**Stoughton Trailers, LLC**

Stoughton Trailers, LLC (Stoughton) has found an area of uncertain performance that needs to be addressed on our 2018 model year AHV model, (commonly referred to as "Grain Haulers" or "Ag Hoppers"). The potential defect is described below:

### Ag Hopper Trailer – Slope Sheet Repair

Repair Document #: **SK-09435**  
Date: April 16, 2018  
Revision:  
Revision Date: N/A

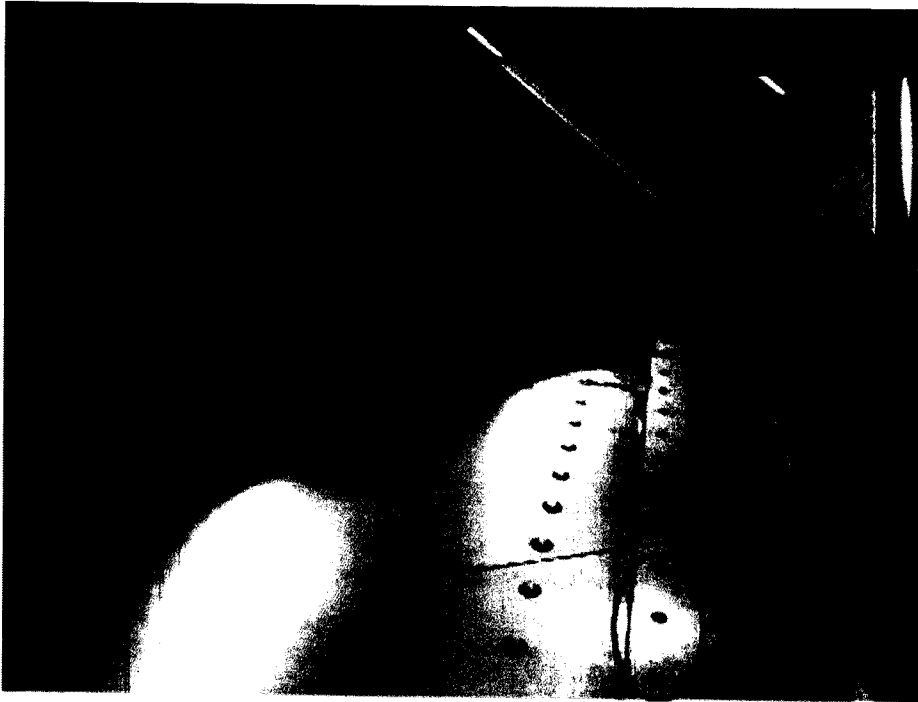
The repair and upgrade addresses inadequately chosen fastener that connects front top slope sheet (6.75" wide) and upper slope sheet. Failure of this fastener causes these two sheets to crack right under side top rail near side walls (see images).

- Front wall tarp cap
- Front top shelf extrusion
- Top slope sheet (6.75" wide)
- Upper slope sheet
- Missing fasteners

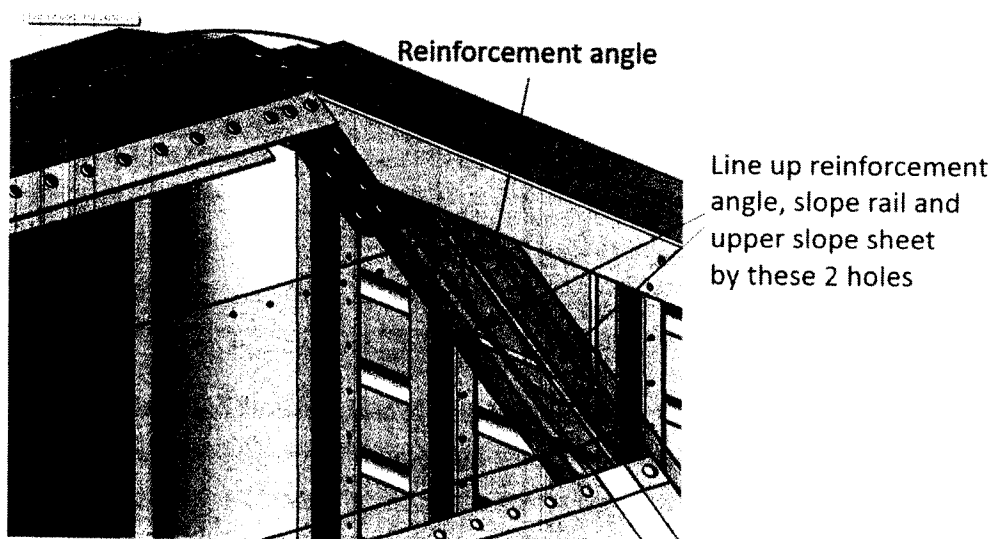
9. From underneath the slope, line up the reinforcement angle SK-09432-000-00 (highlighted yellow on picture below, upper slope sheet and slope rail are transparent) with existing holes in upper slope sheet and slope rail. Install (2) 1/4-20x1 bolts, washers on both sides and nuts without tightening them all the way.

Transfer drill (4) 1/4" holes and install (4) mono-bolts 04-97083-000-00

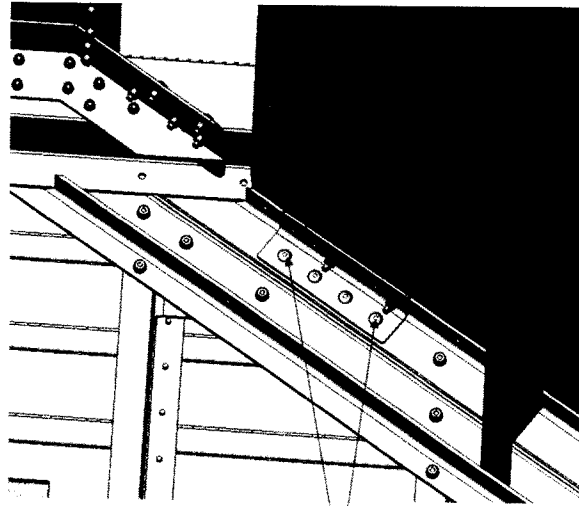
10. Holding reinforcement angle tight against both mating surfaces- slope rail web and bottom side of slope rail flange, transfer drill (4) 1/4" DIA holes through slope rail web. Install (4) 1/4" DIA blind rivets (04-97083-000-00 SST monobolts, .350"-.625" GP) (See below).

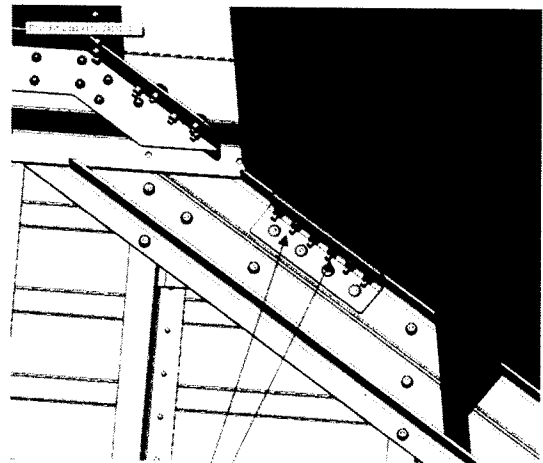
11. Using 5" or longer 1/4" DIA drill bit, transfer drill remaining (4) holes into slope rail flange and upper slope sheet, holes will end up under slight angle. Install (4) 1/4-20x1 bolts, washers on both sides and nuts, at this point tighten all (6) nuts. (See below).
12. Repeat steps 9-11 on the other side of the trailer.

Transfer drill (4) 1/4" with 5" or longer drill bit

Install remaining (4) 1/4-20x1 bolts, washers on both sides and nuts, tighten all (6) nuts

Fasten with 04-98003-750-00 rivet,  
(1) per side

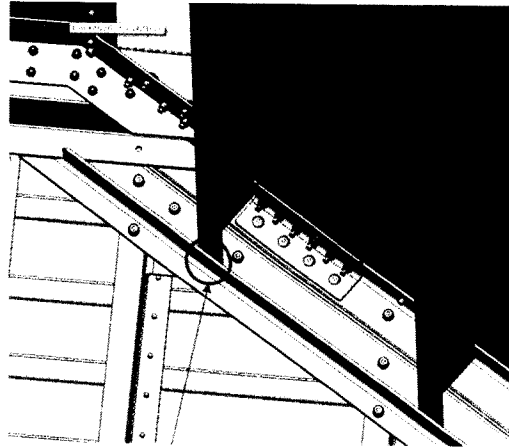
13. Reinstall top zee post and fasten it at the bottom flange with (2) solid rivets 04-98003-750-00 (1 per side) (See below). If damage occurred to bottom flange of the slope rail, then refer to Appendix A.1.

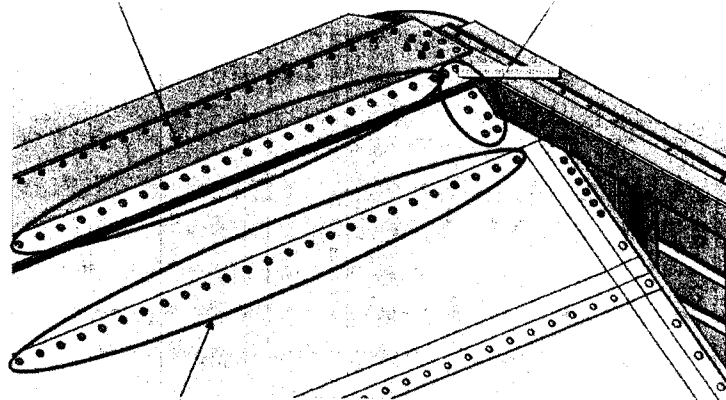
Enlarge hole DIA to 17/64". Fasten with (41) 04-97100-000-00 pins and 04-97116-000-00 collars

Fasten with (7) per side 04-97103-000-00 pins and 04-97116-000-00 collars

Transfer drill (43) 17/64" holes into top slope sheet (10.25" wide). Fasten with (43) 04-97100-000-00 pins and 04-97116-000-00 collars

14. Reinstall revised top slope sheet that is now 10.25" wide, it will reside over top of both- top shelf and upper slope sheet and fasten with (7) per side ((14) total) 04-97103-000-00 pins 1/4" DIA and 04-97116-000-00 collars at steel reinforcement bracket connection with all pin heads on outside and collars on the inside.

15. Drill out (41) 13/64" dia to 17/64" dia holes in revised top slope sheet (10.25" wide) and top shelf. Fasten with (41) 04-97100-000-00 pins 1/4" DIA and 04-97116-000-00 collars at top shelf lap (pin heads on the outside and collars on the inside).

16. Using holes in zee post and upper slope sheet, transfer drill (43) 17/64" holes from underneath the slope into top slope sheet (10.25" wide). Fasten top slope sheet (10.25" wide), upper slope sheet and zee post with (43) 04-97100-000-00 pins 1/4" DIA and 04-97116-000-00 collars (pin heads on the outside and collars on the inside) (See below).
